# Wisconsin Department of Transportation

**Proposal #34: 1198-00-78, WISC 2018 256**  
**Minong - Superior**  
**CTH L Intersection**  
**USH 53**  
**Douglas County**

### Letting of May 8, 2018

This is Addendum No. 01, which provides for the following:

Addendum No. 01  
 ID 1198-00-78  
 Revised Sheet 6  
 April 30, 2018

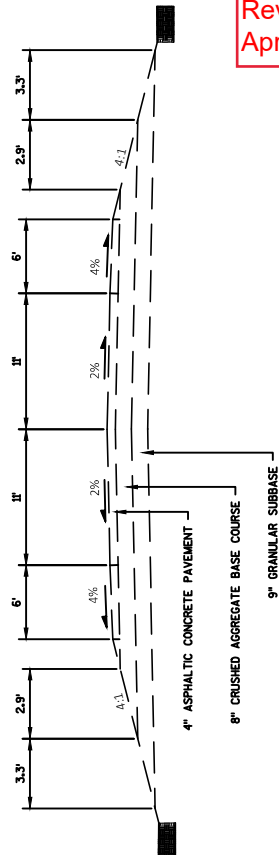
<b>Revised Plan Sheets</b>	
Plan Sheet	Plan Sheet Title (brief description of changes to sheet)
6	Typical Section Sheet – Revised HMA Pavement Type Upper Layer : 4 MT 58-34 H
7	Typical Section Sheet – Revised HMA Pavement Type Upper Layer : 4 MT 58-34 H
25	MQ Sheet – Revised HMA Pavement Column for revised pavement 4 MT 58-34 H

Addendum No. 01  
ID 1198-02-82  
Revised Sheet 4  
April 30, 2018

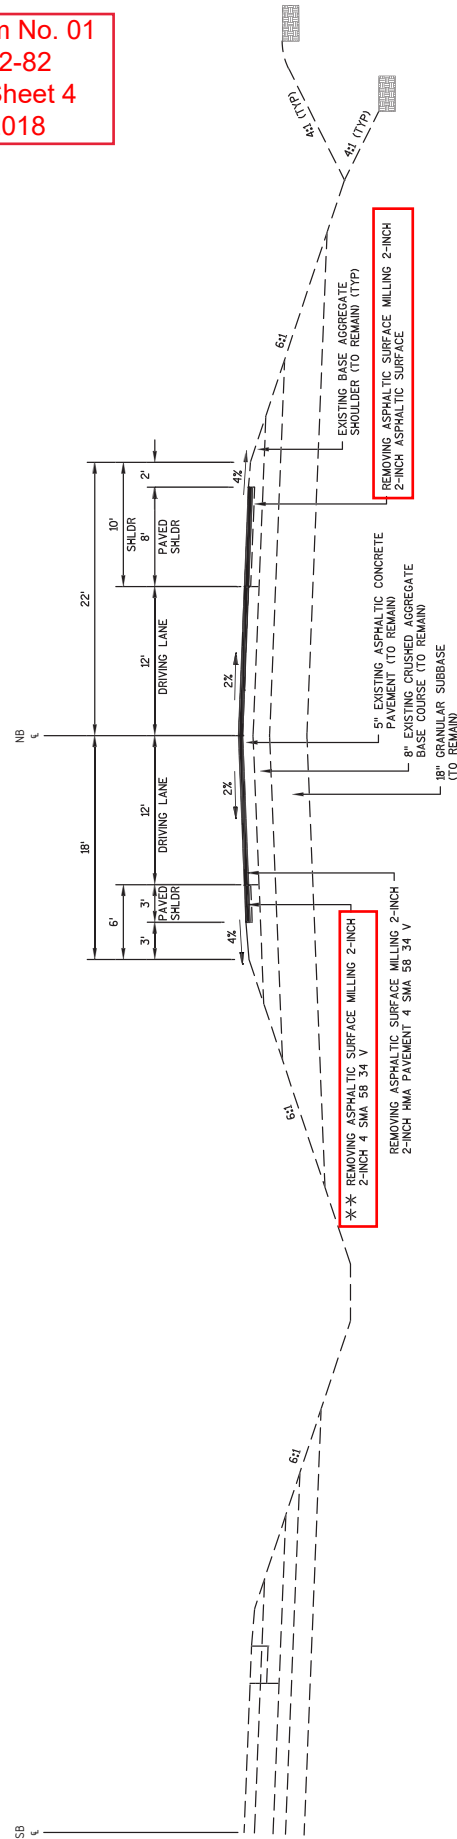
<b>Revised Plan Sheets</b>	
Plan Sheet	Plan Sheet Title (brief description of changes to sheet)
4	Typical Section Sheet - Revised HMA Pavement Type Upper Layer : 4 MT 58-34 H
6	Construction Detail Sheet – Revised Pavement Types on Detail
59	MQ Sheet – Revised Table – 3 columns revised with new pavement types
61	MQ Sheet – Revised Table – Excavation Common for information only

\* SEE PROJECT 1198-00-78 TYPICALS BETWEEN STA 357-15 - STA 375+90  
\*\* ASPHALTIC SURFACE- MINIMUM MIX OF A 4LT 58-34-S WILL BE USED

Addendum No. 01  
ID 1198-02-82  
Revised Sheet 61  
April 30, 2018

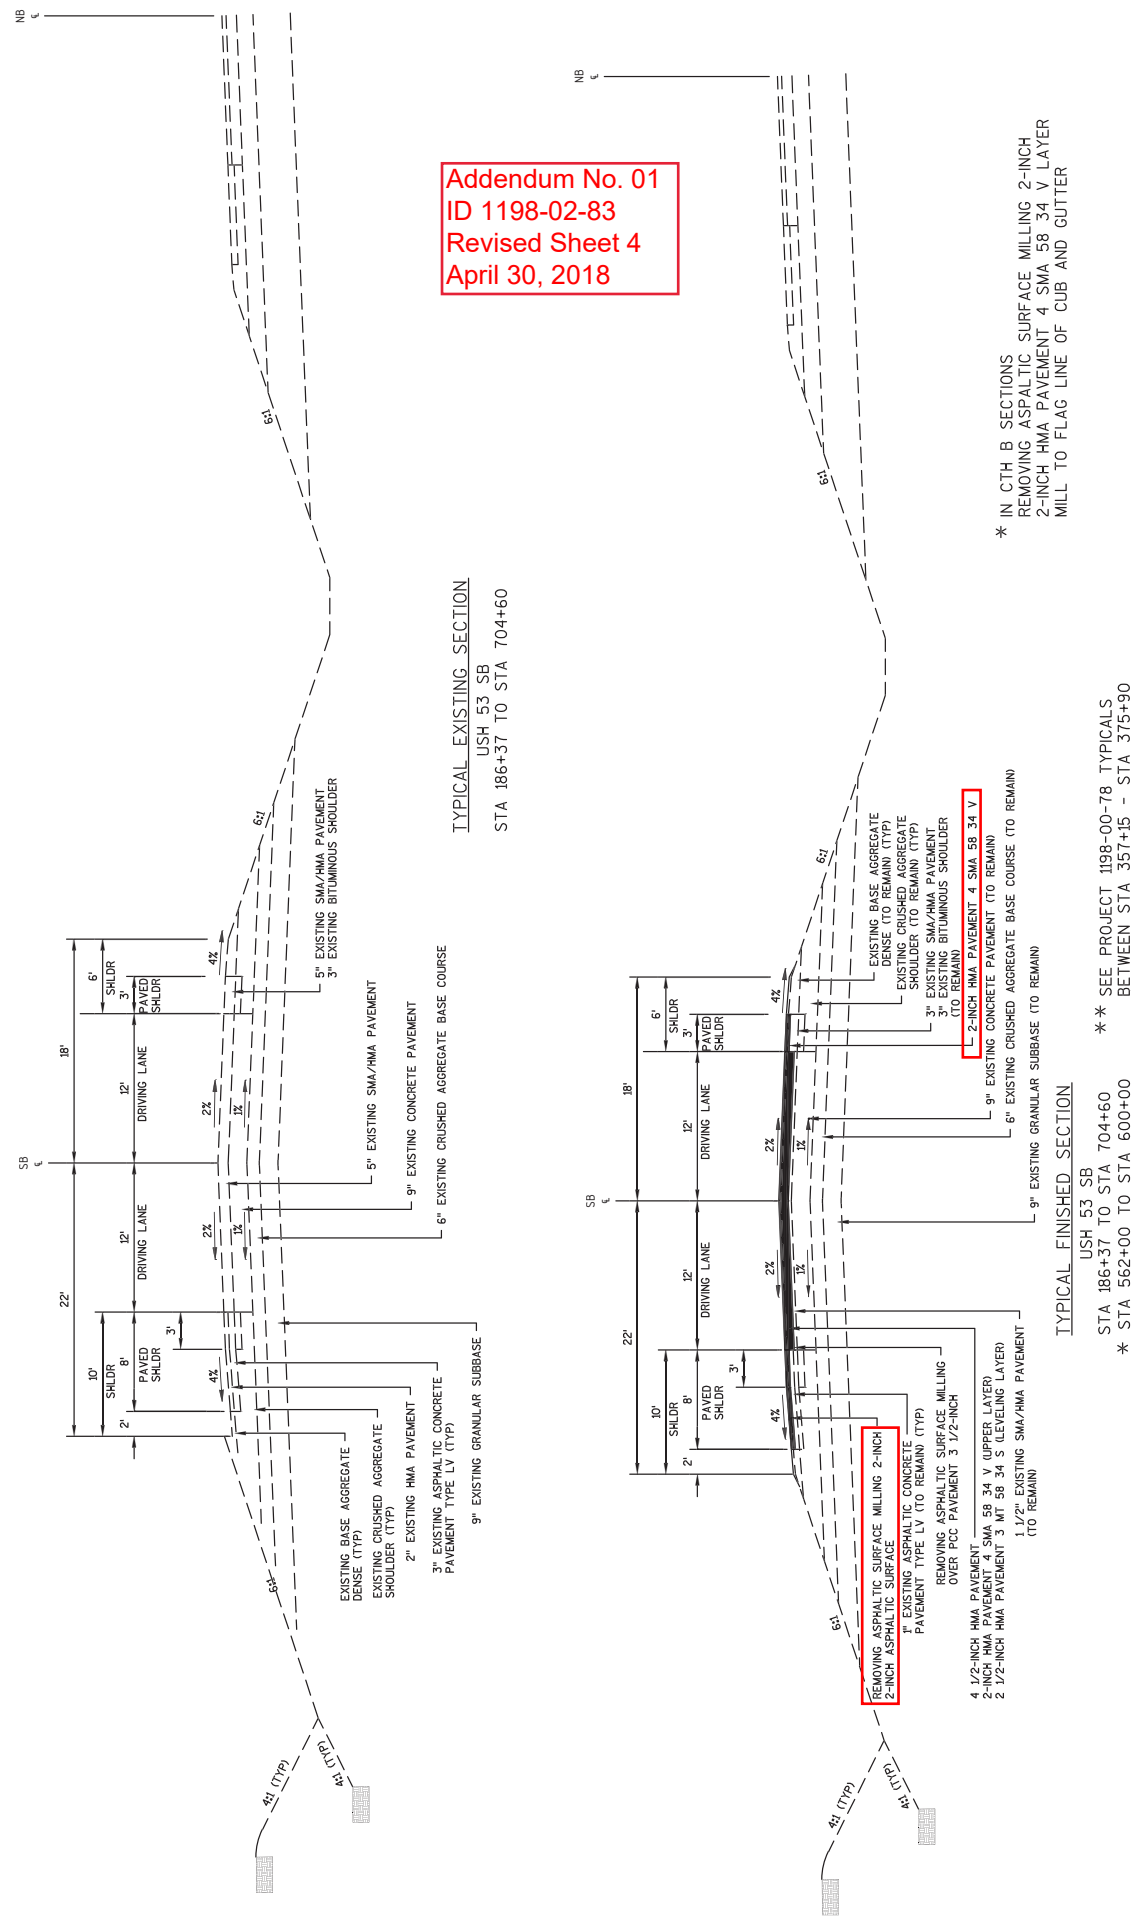
\* QUANTITIES ALSO SHOWN ELSEWHERE.  
\*\* FOR INFORMATION ONLY, EXCAVATION COMMON IS INCIDENTAL TO THE PIPE INSTALLATION  
\*\*\* SALVAGED TOPSOIL, MULCHING, SEED AND FERTILIZER IF REQUIRED AT DITCH CLEANING AREAS ARE INCIDENTAL TO THE DITCH CLEANING ITEM.

Addendum No. 01  
 ID 1198-02-83  
 Revised Sheet 9  
 April 30, 2018

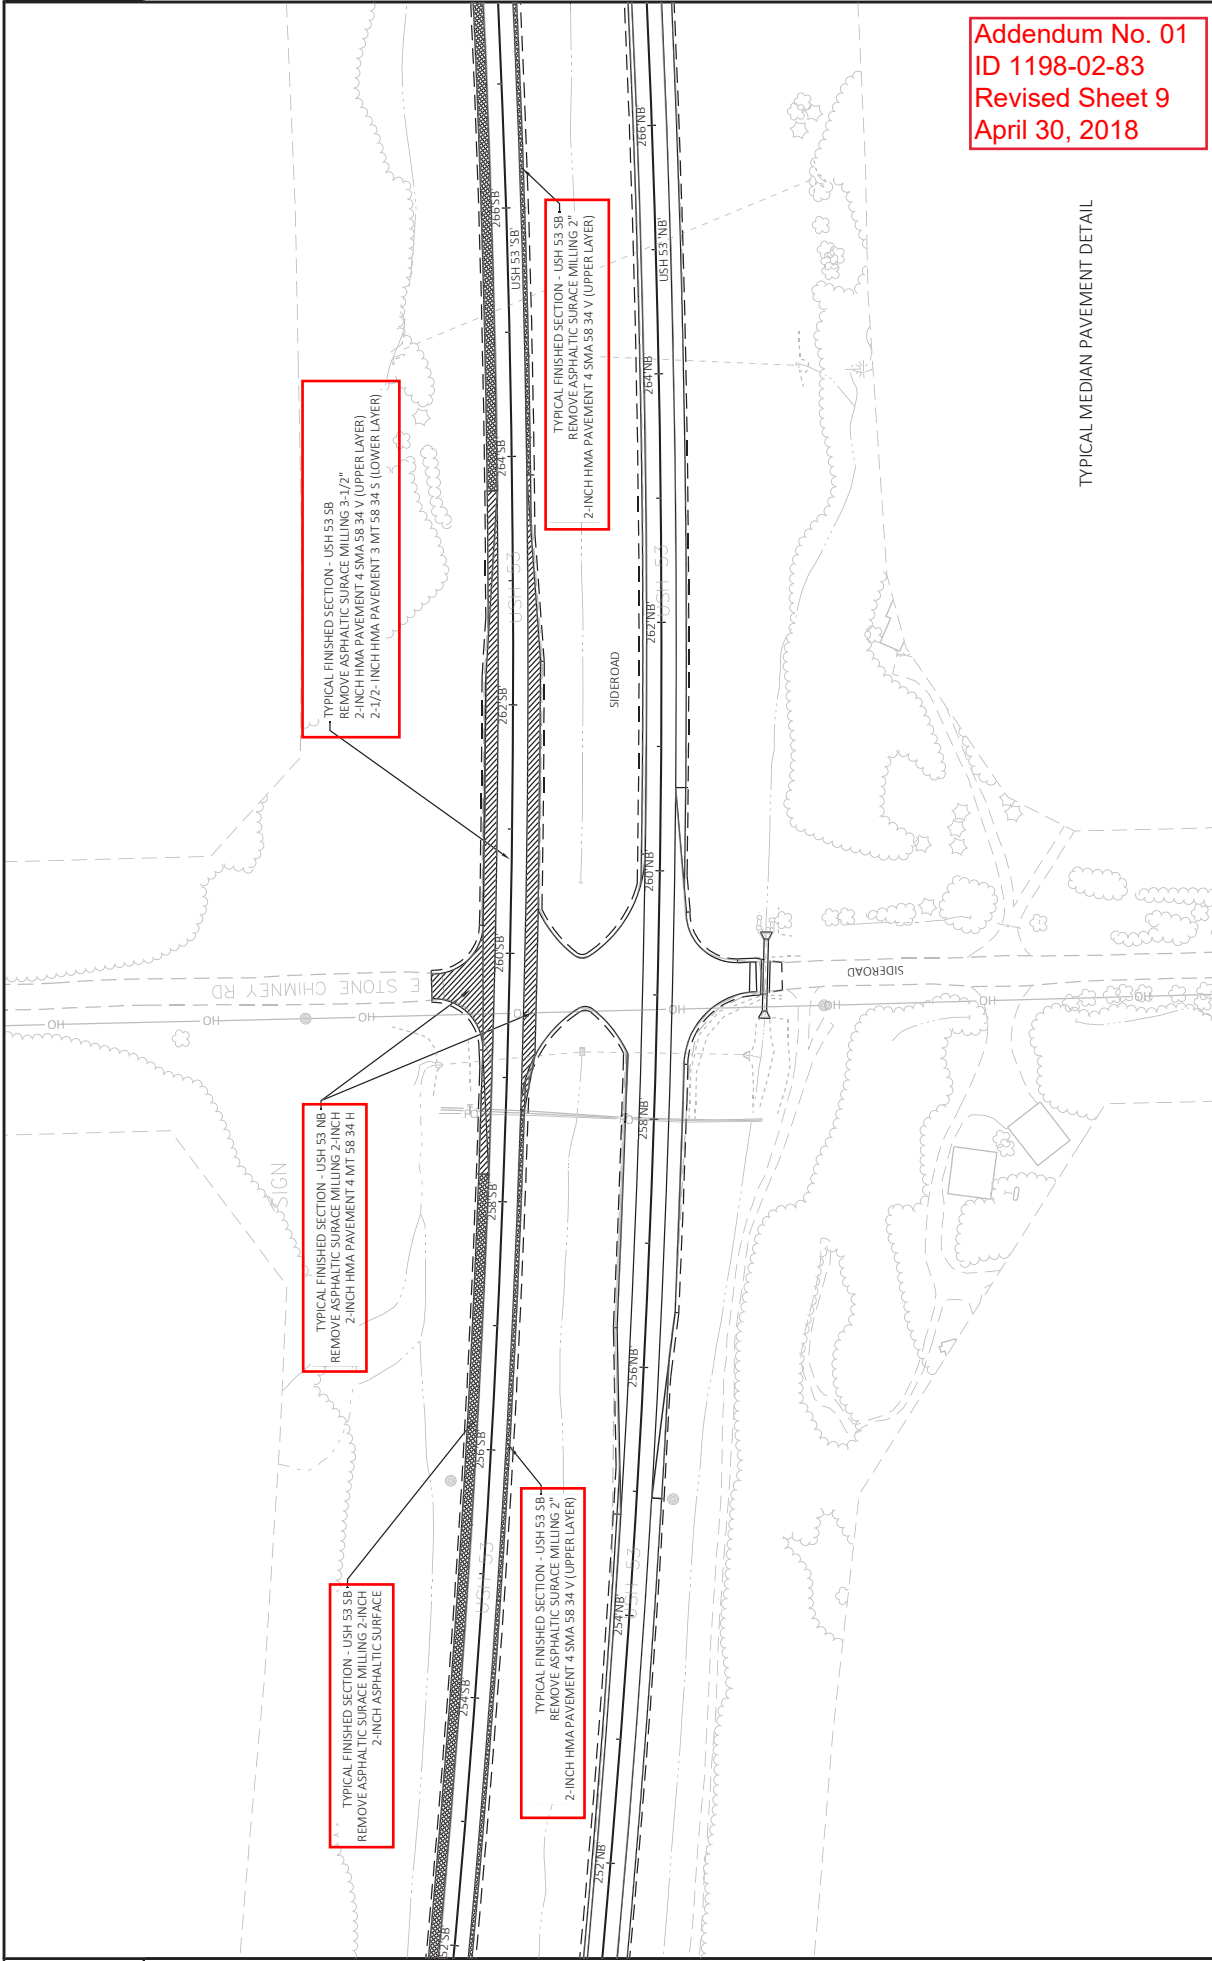
<b>Revised Plan Sheets</b>	
Plan Sheet	Plan Sheet Title (brief description of changes to sheet)
4	Typical Section Sheet - Revised HMA Pavement Type Upper Layer : 4 MT 58-34 H
9	Construction Detail Sheet – Revised Pavement Types on Detail
59	MQ Sheet – Revised HMA Pavement Test Strip Table, Excavation for information only
60	MQ Sheet – Revised Table - 3 columns revised with new pavement types
66	MQ Sheet - Added PWL Mixture Use Table
